## Change Notification for Polymer Surface Mount to Black Epoxy Resin

AVX will be transitioning from Gold to Black epoxy resin for all Polymer surface mount capacitors in order to standardize the production process and materials. Eventually all Polymer series will be changed prior to July 2020. Affected series include:

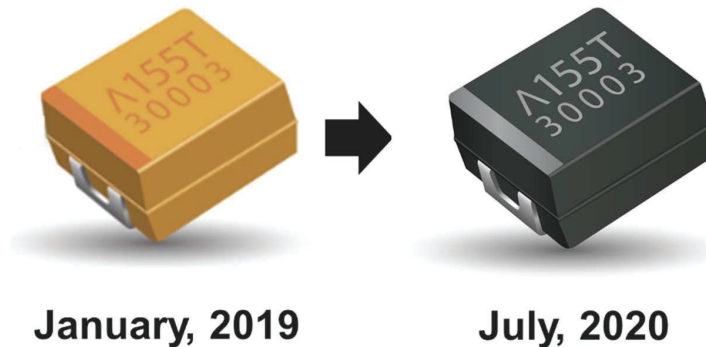
An “E” suffix will be added to individual PN’s to reflect the resin color change and all catalog series data sheets will be updated with the new PN’s:

Example: TCQD337M006R0025 → TCQD337M006R0025E
